ADDENDUM # 1

DATE: April 11, 2025

**FOR: PCDL – NEW LEXINGTON
ADDITION & RENOVATION**

NEW CONSTRUCTION UPPER LEVEL FLOOR PLAN

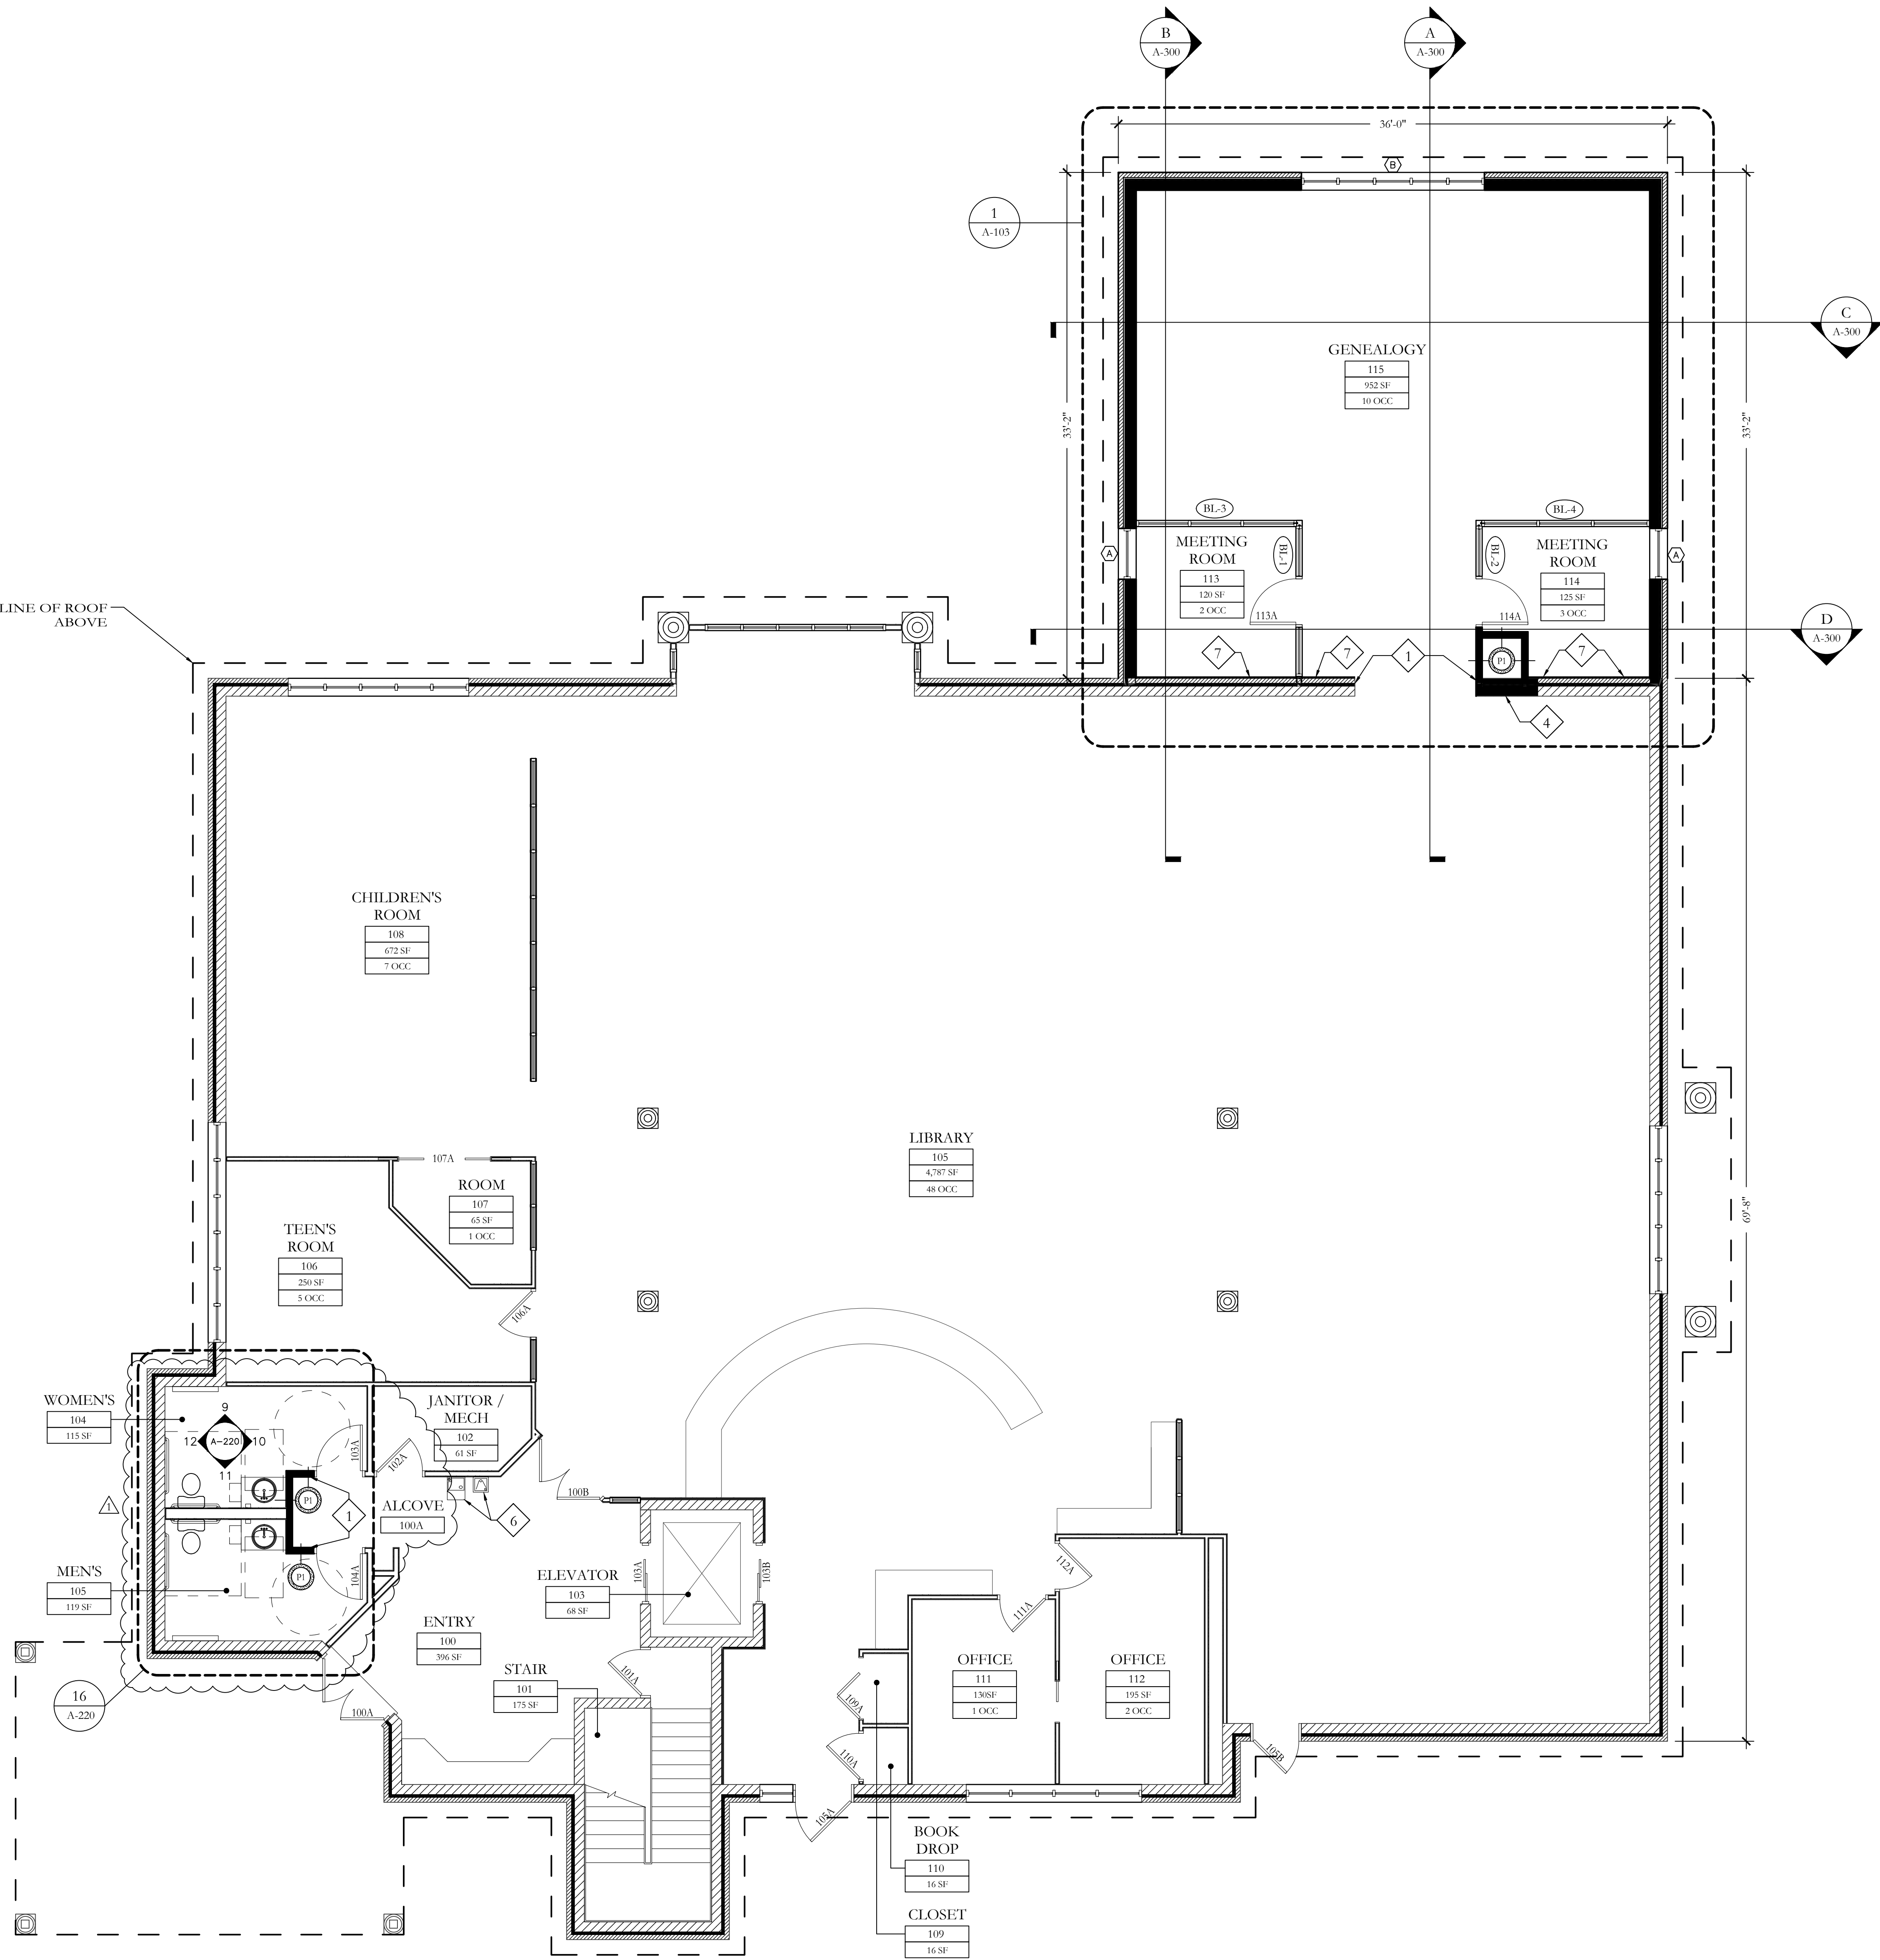
Item #4 New Construction Upper-Level Floor Plan – replace A-102 with attached

- a. Remove paper towel dispensers in restrooms (Women’s 004, Men’s 005, Women’s 103, Men’s 104) – Owner will furnish paper towel dispensers, and Contractor will install.
- b. Added missing existing door #102A (Janitor/Mech 102)

LOWER LEVEL
FINISH FLOOR
PLAN

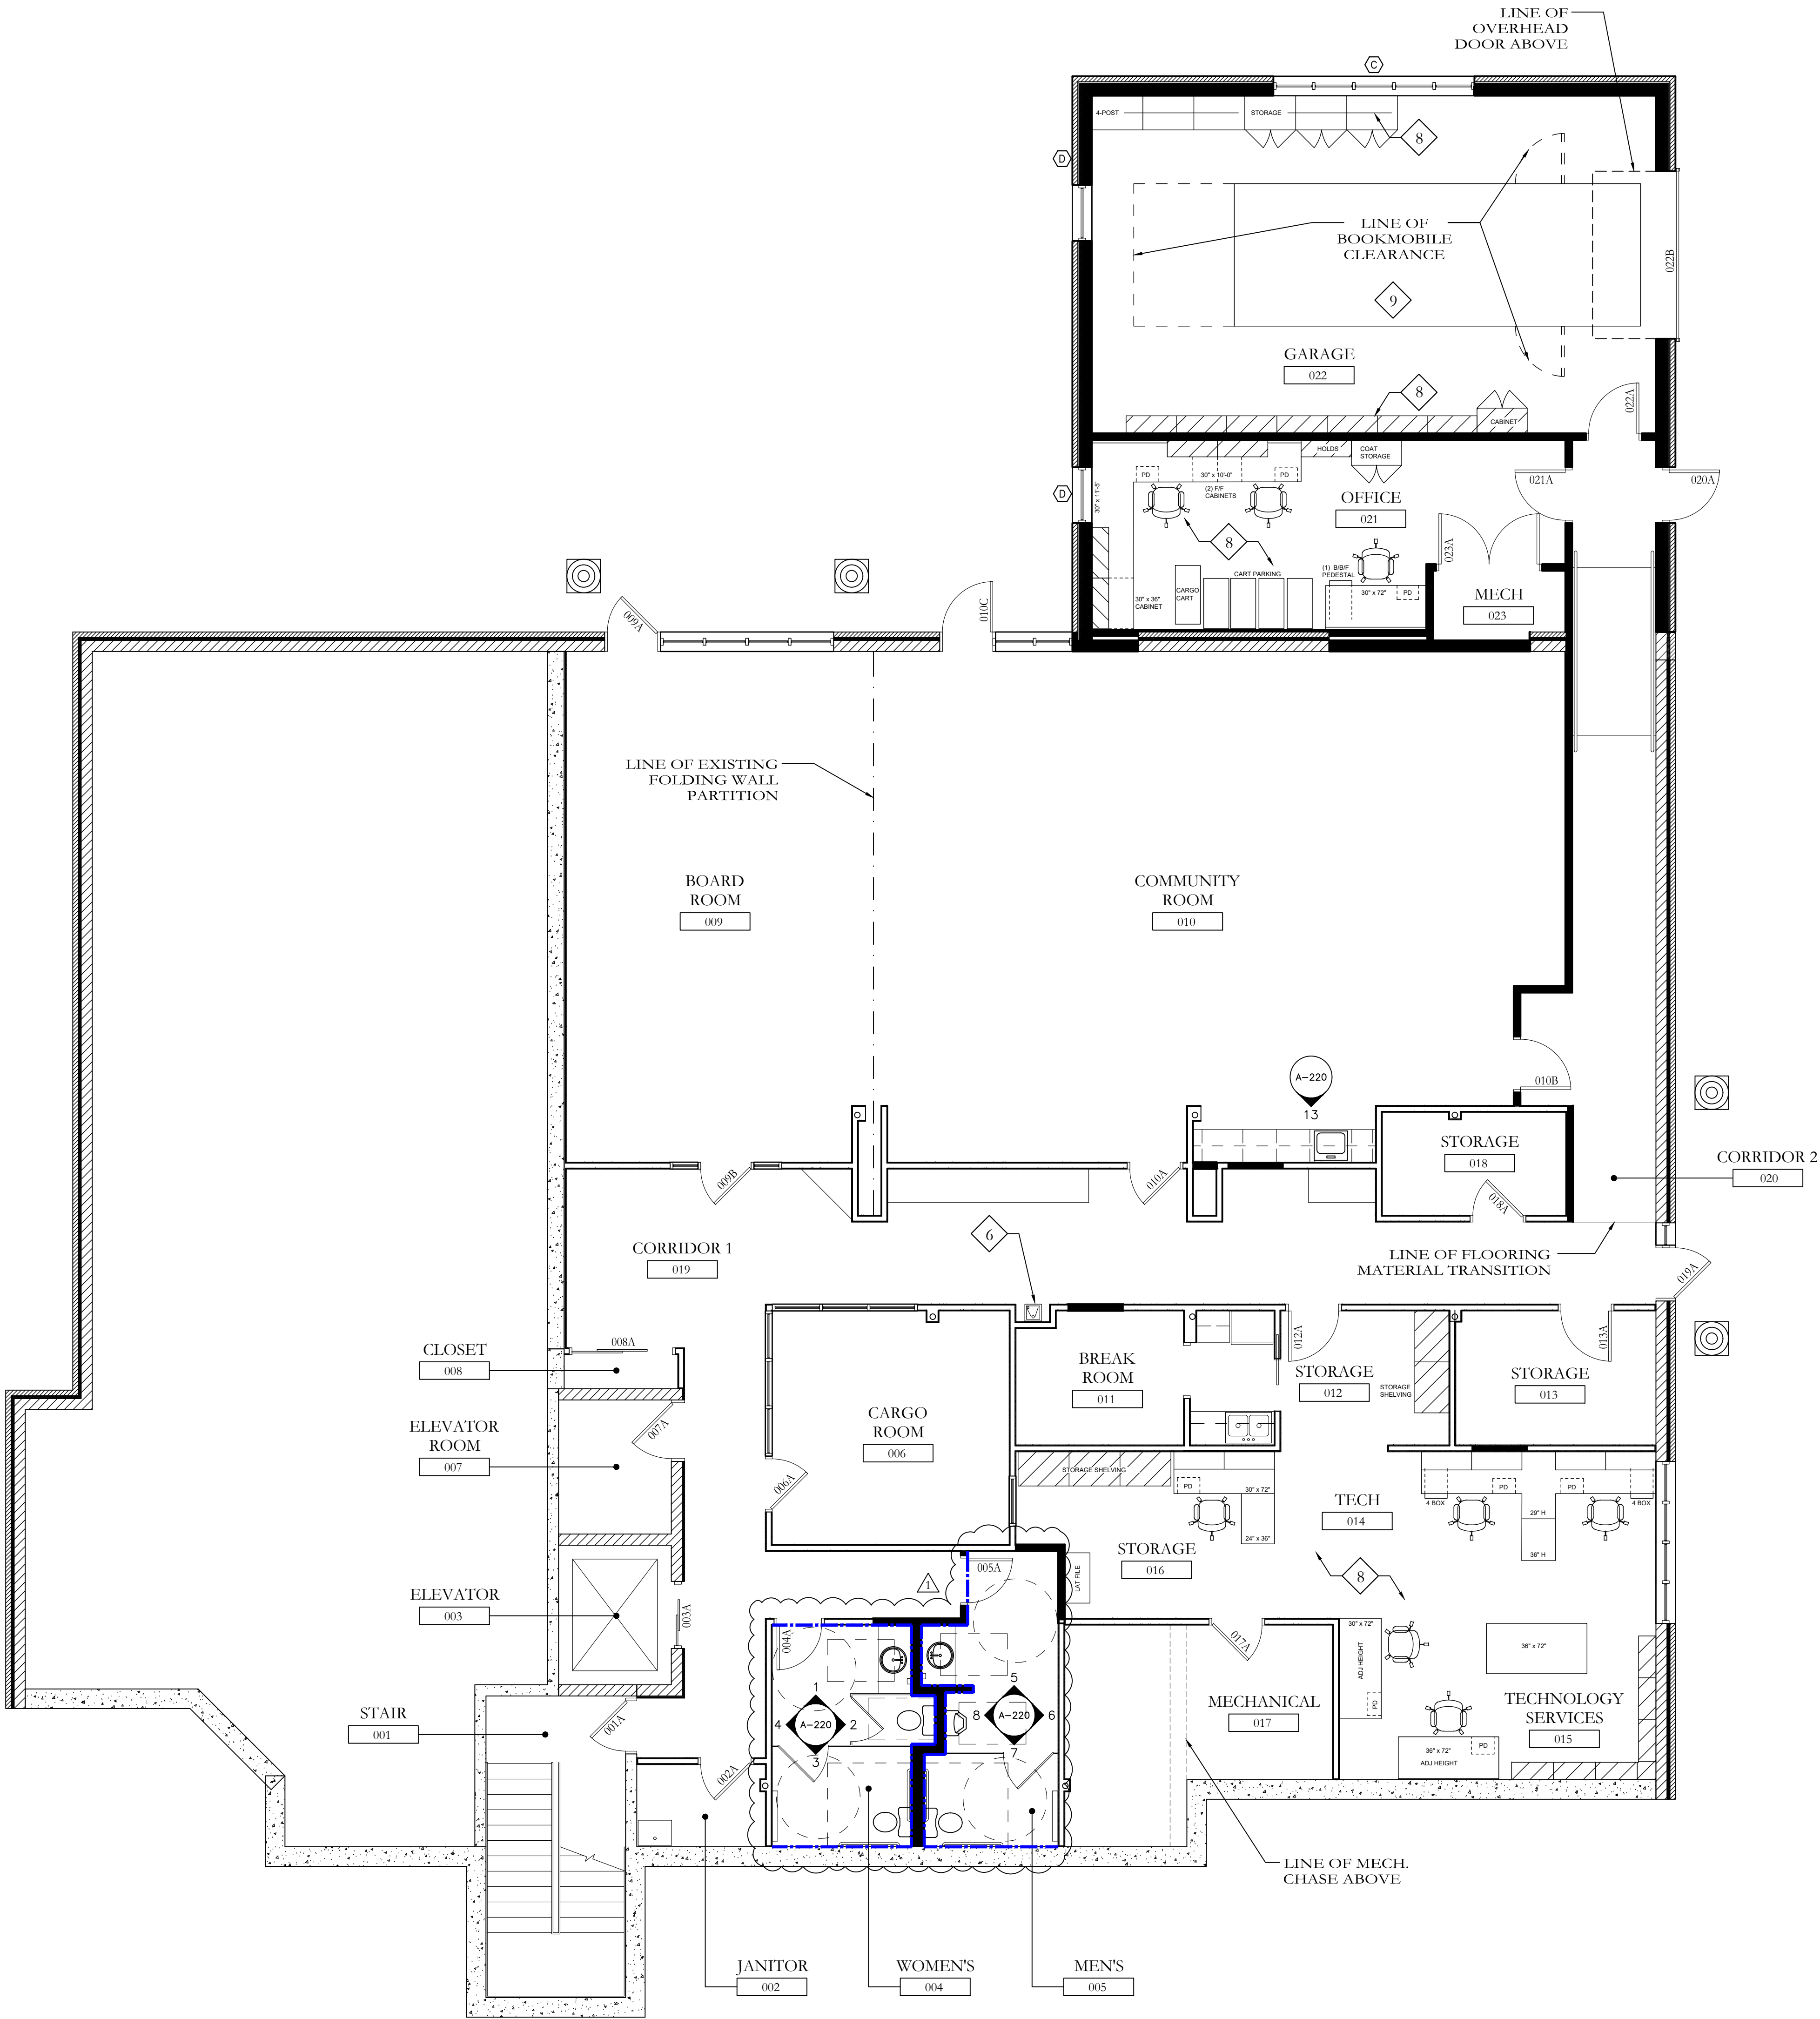
Item #5 Lower-Level Finish Floor Plan – replace A-104 with attached

- a. Remove paper towel dispensers in restrooms (Women’s 004, Men’s 005, Women’s 103, Men’s 104) – Owner will furnish paper towel dispensers, and Contractor will install.
- b. Added missing existing door #102A (Janitor/Mech 102)

A-105

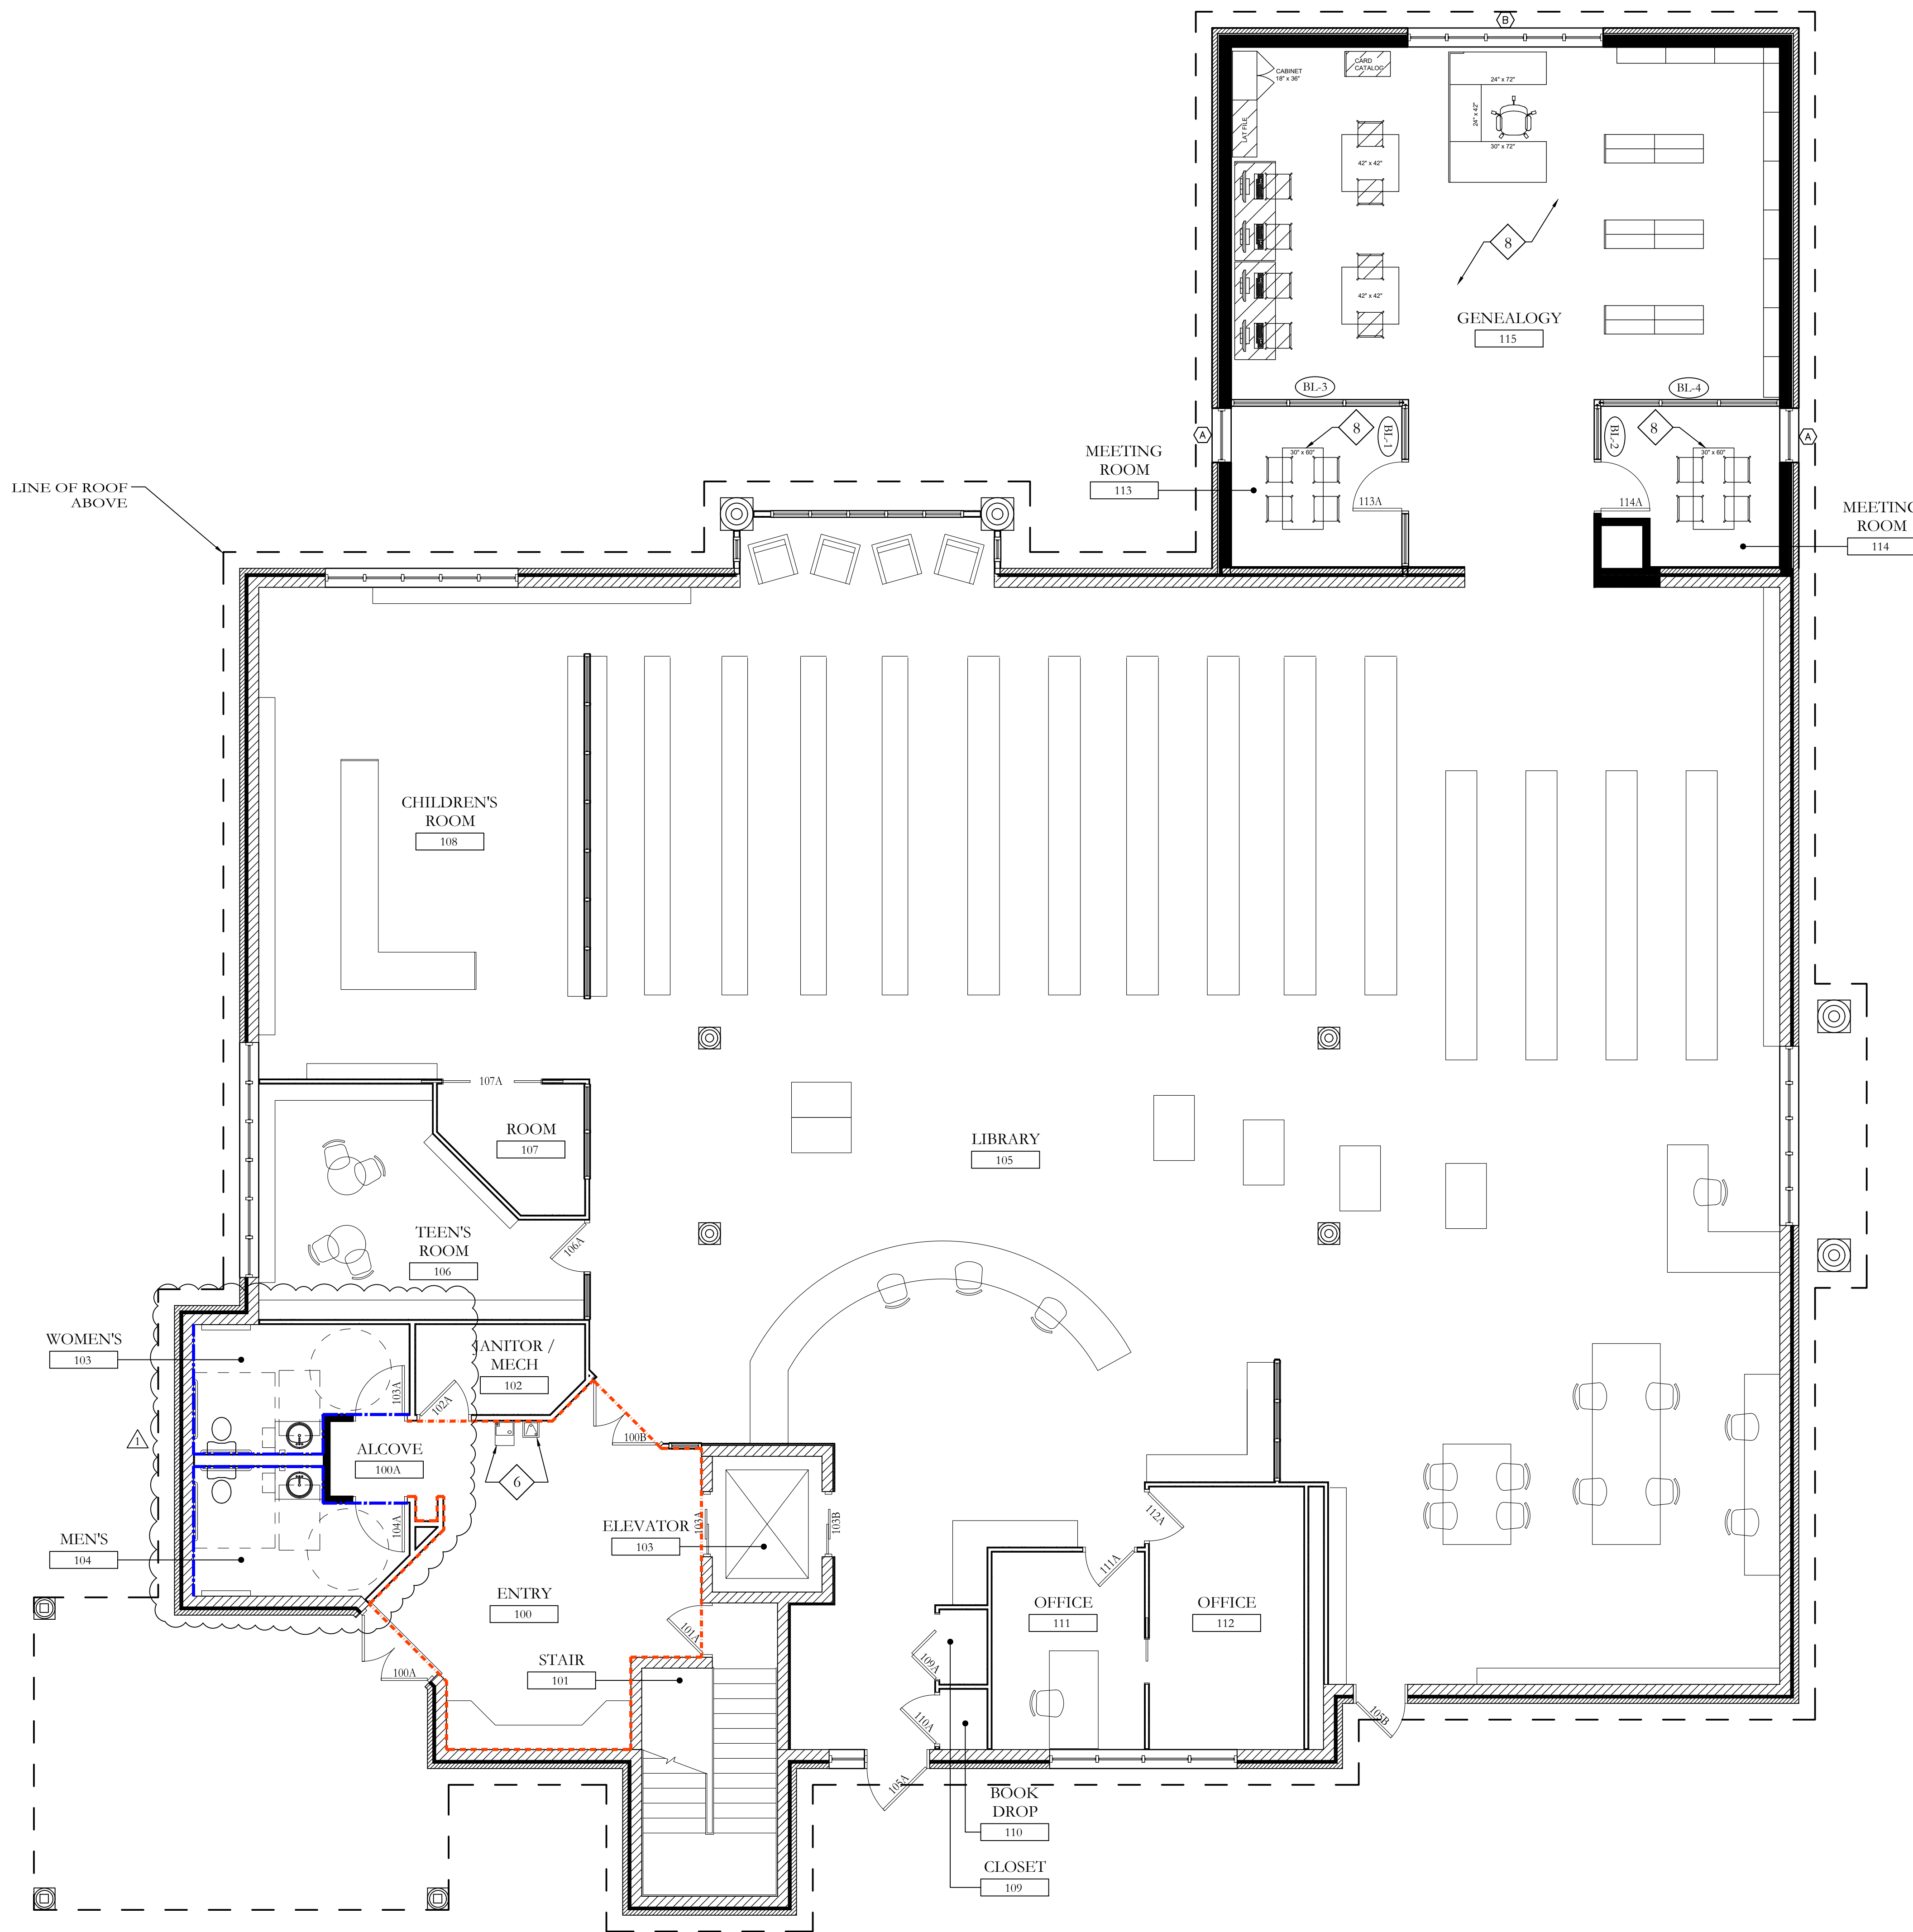
Item #6 Upper-Level Finish Floor Plan – replace A-105 with attached

- a. Remove paper towel dispensers in restrooms (Women’s 004, Men’s 005, Women’s 103, Men’s 104) – Owner will furnish paper towel dispensers, and Contractor will install.
- b. Added missing existing door #102A (Janitor/Mech 102)
- c. Alternate GC-1 to include floor tile at upper landing in Stair 101
